LAKE HAVASU CITY, ARIZONA  
ADMINISTRATIVE SERVICES DEPARTMENT  
♦ PROCUREMENT ♦

**INVITATION TO BID**  
**ASPHALT REHAB LONDON BRIDGE BEACH AND CYPRESS NEW**  
**PARKING LOT/STREET WIDENING**  
**B25-PW-500679**  
**ADDENDUM NO. 2**  
**MAY 14, 2025**

300

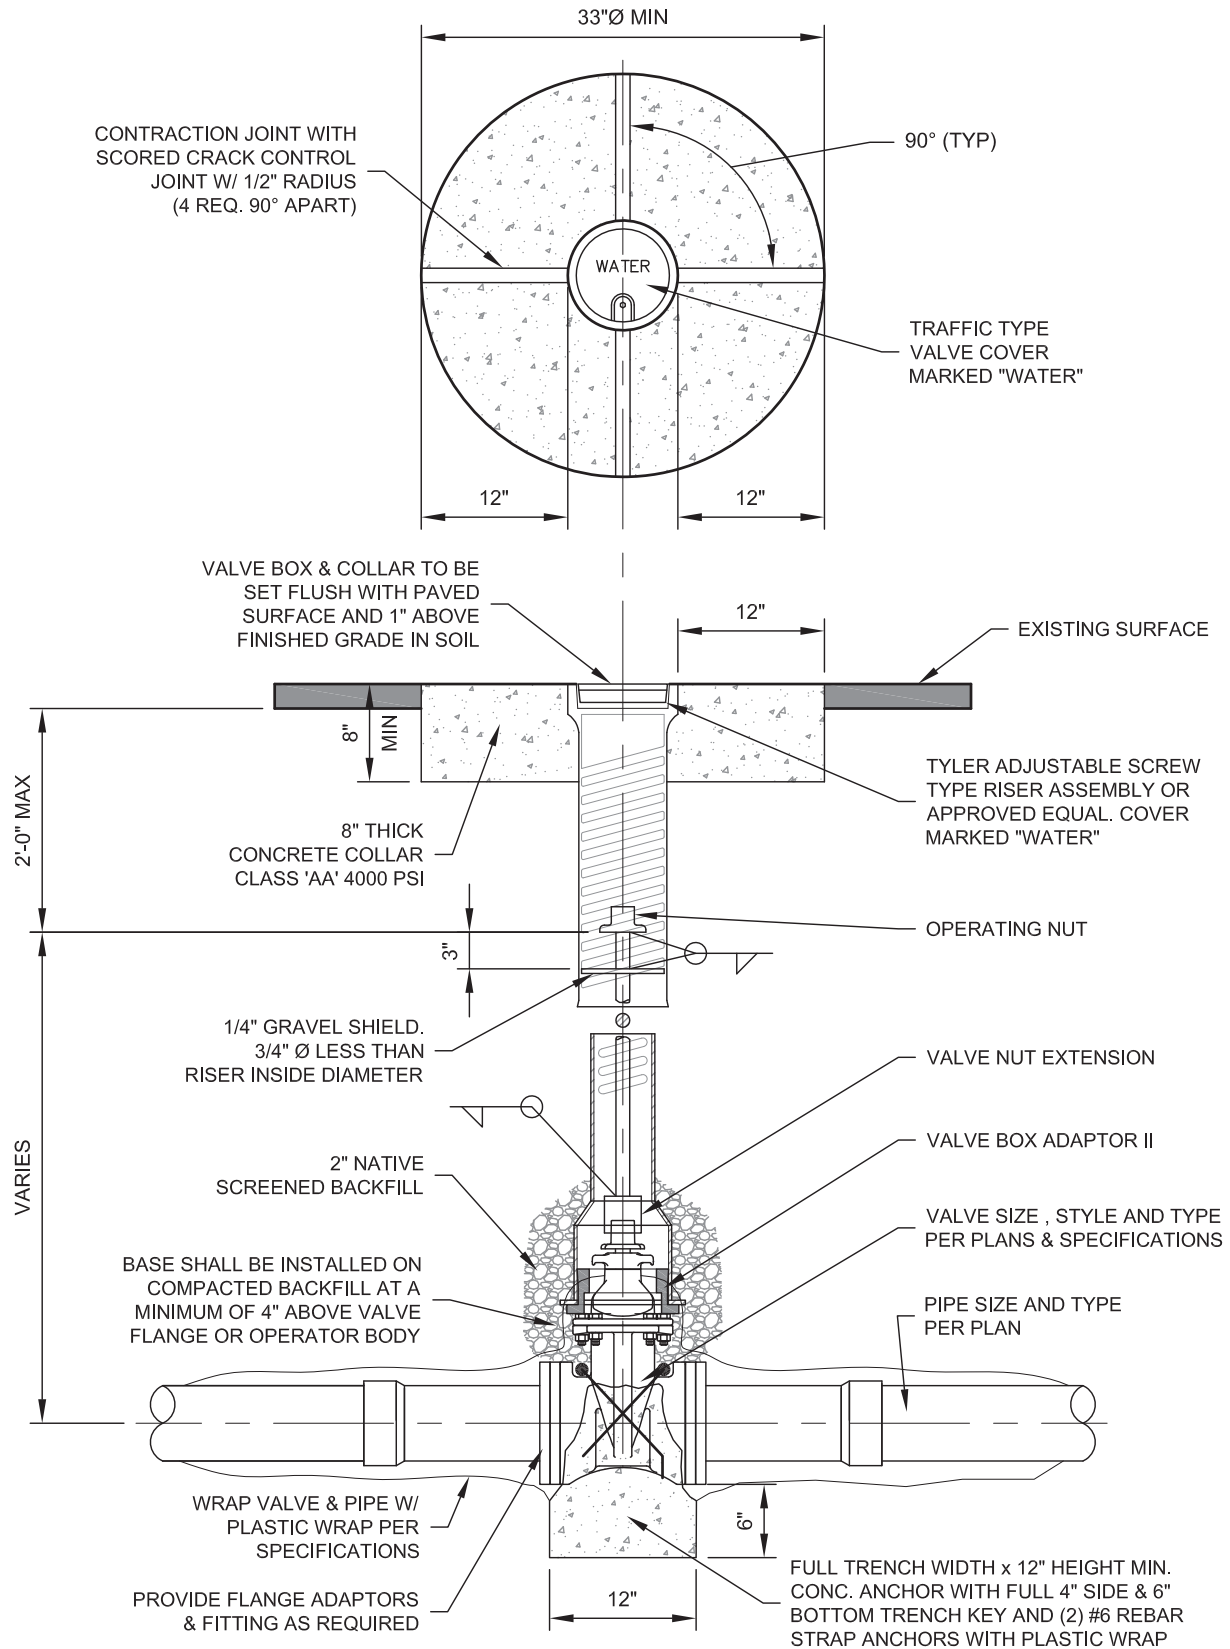
**Question 7:** Adjustment Detail Specifications: Please provide detail drawings and material specifications for the adjustment of manholes and water valves.

**Answer 7:** *The City will lower all manholes and water valves. The contractor will be required to raise water valves to grade and construct a concrete collar per typical detail 300. The contractor will also be required to adjust the manhole to grade with a concrete collar per detail 403 presented as Attachment A to this Addendum.*
